**9A Fire Hazards Analysis**

The information in this appendix of the reference ABWR DCD, including all subsections, tables, and figures, as modified by the STP Nuclear Operating Company Application to Amend the Design Certification rule for the U.S. Advanced Boiling Water Reactor (ABWR), "ABWR STP Aircraft Impact Assessment (AIA) Amendment Revision 3," dated September 23, 2010 is incorporated by reference with the following departures and supplement to 9A.1 Introduction. Additionally, the Fire Hazards Analysis for the Turbine Building in Section 9A.4.3 is replaced in its entirety.

**Figure 9A.5-2 Typical Electrical Equipment Connection Block Diagrams of Special Cases**

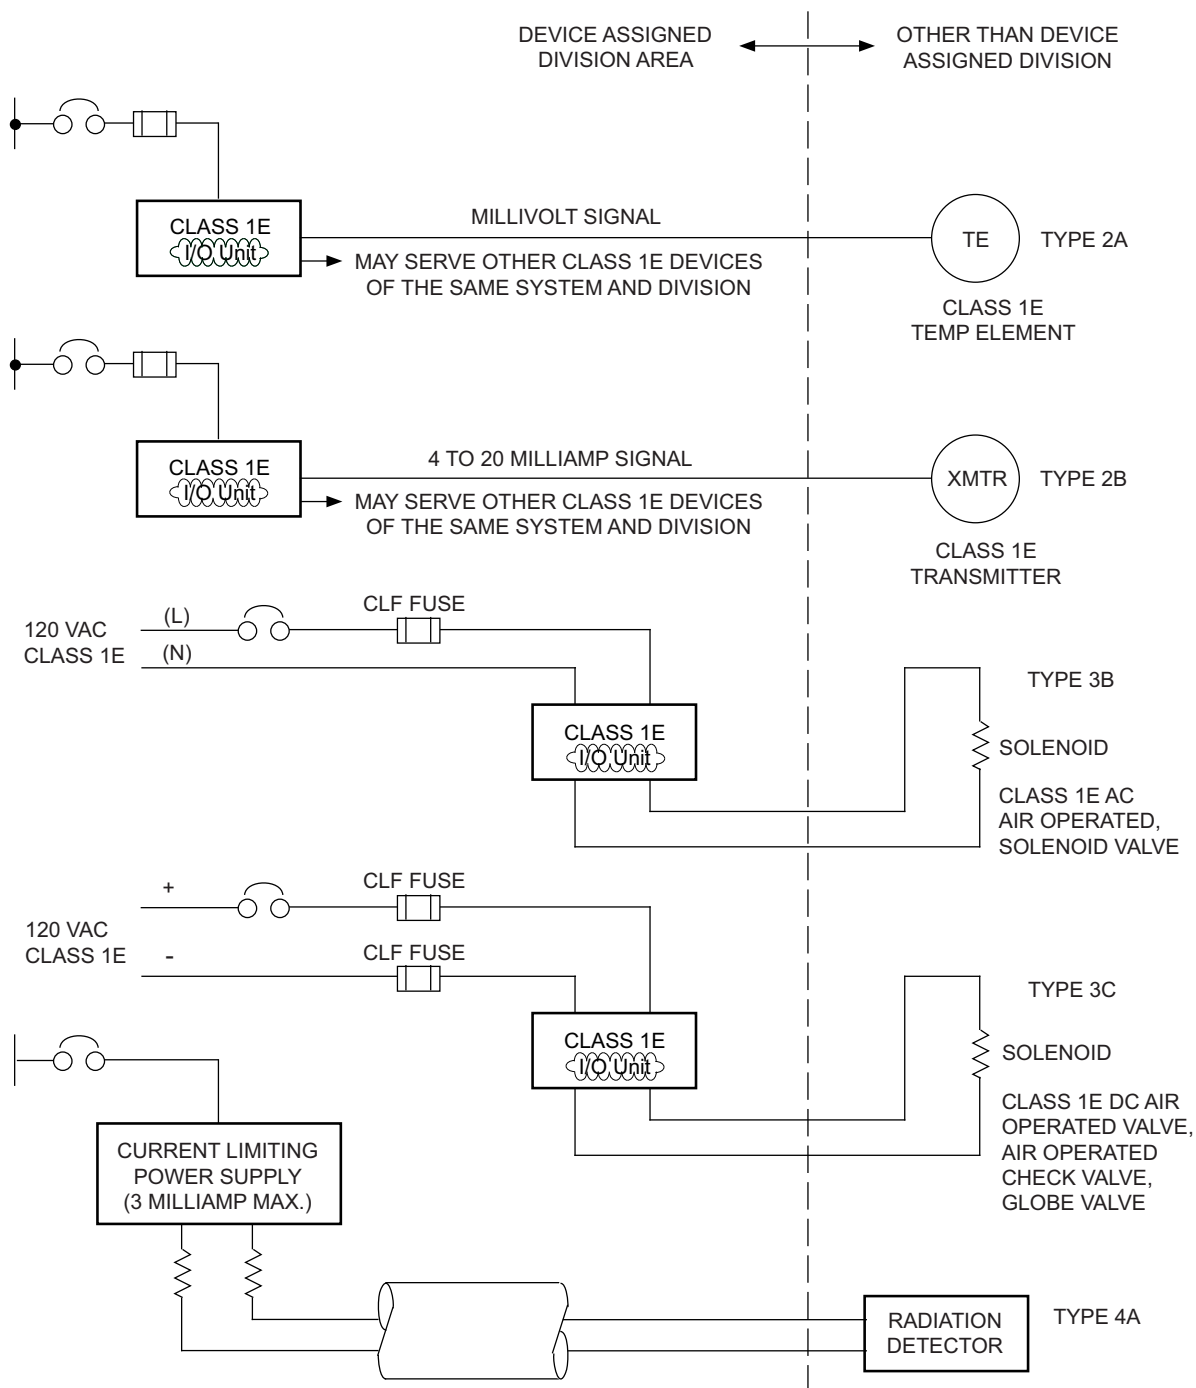
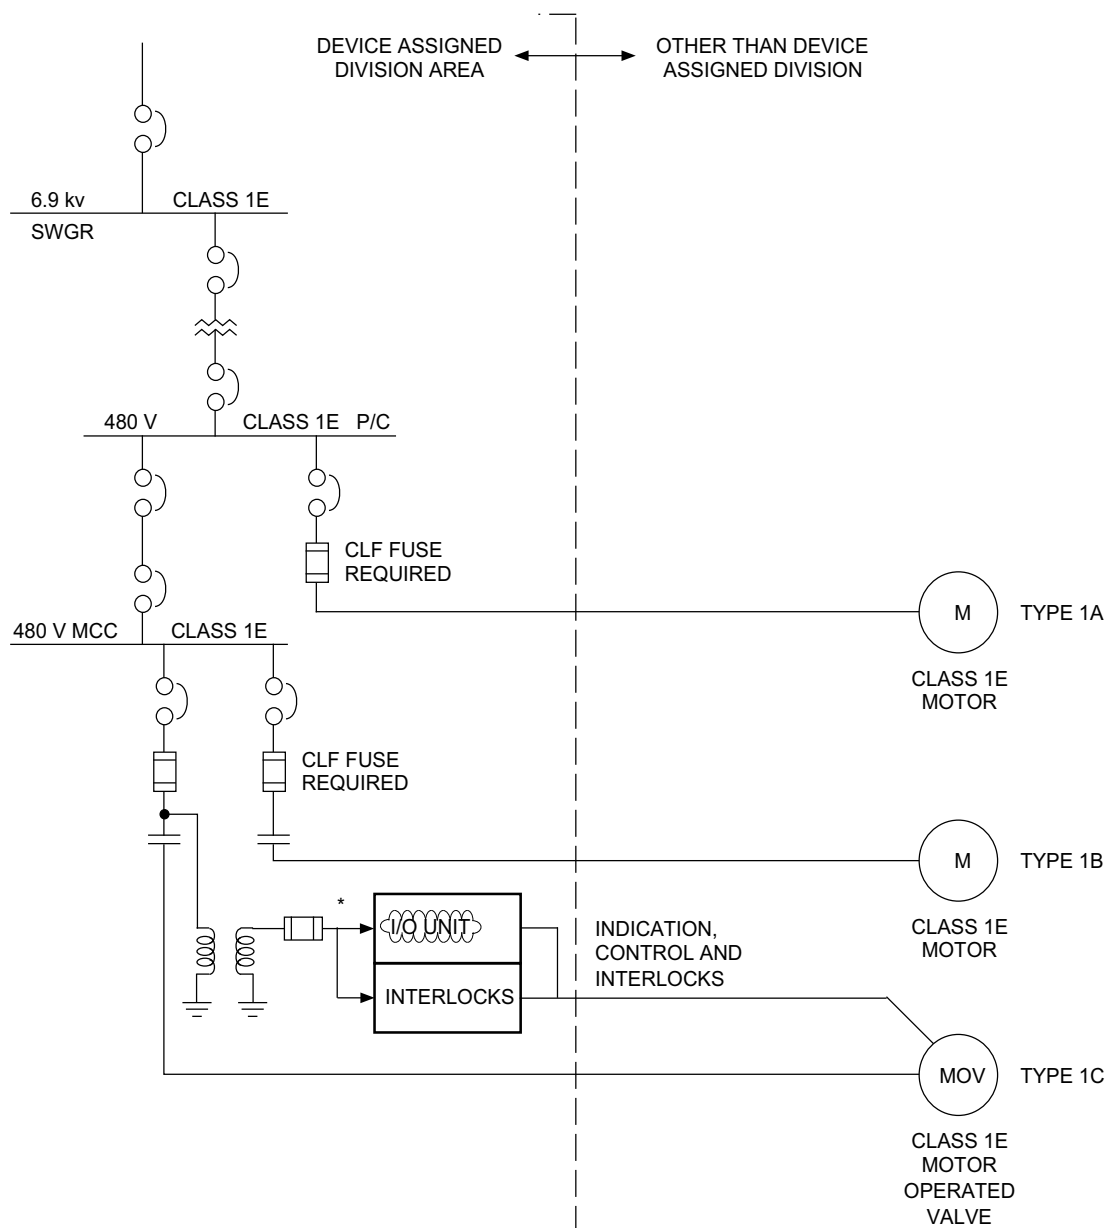
STD DEP T1 3.4-1 (Figure 9A.5-2)

*The power for operating DC solenoid valves is supplied from the DC distribution system to the ~~demultiplexer~~ I/O unit for the valve. Both the supply and return for the DC are fused ~~at the multiplexer~~ so that faults are isolated and do not propagate back up into the portions of the DC system common with other systems.*
